Access Compliance Report

Public Rights-of-Way

(Pedestrian Signals)

Intersection ID: N/A	Main Street:	Cross Street: N/A	Location: N/A
ADA ID: 9CC14C14B0BA	Signal Type: One Push Button-Non APS	Overall Compliance: No	Severity Score: BTN 1: N/A BTN 2: N/A No BTN: N/A
Codes/Mitigation Info/Possible Solution		Field Measurements/Component Compliance

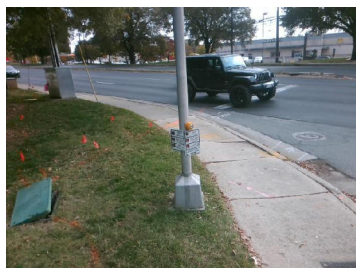
PROW/ADA: TMUTCD 4e.08, R404.2, R404.7.3

Yes	B 1 Clear Xing Direction?	ClearlyMarked	N/A	B 2 Clear Xing Direction?	N/A
	B 1 Crossing Direction	To SE		B 2 Crossing Direction	N/A
No	B 1 DistanceTo XWalk (in)	65.0	N/A	B 2 DistanceTo XWalk (in)	N/A
No	B 1 DistanceTo Curb (in)	83.0	N/A	B 2 DistanceTo Curb (in)	N/A
Yes	B 1 Diameter (in)	2.0	N/A	B 2 Diameter (in)	N/A

Possible Solutions: Replace Signal Push Button With APS Button on New Post. Remove & Relocate Sign.
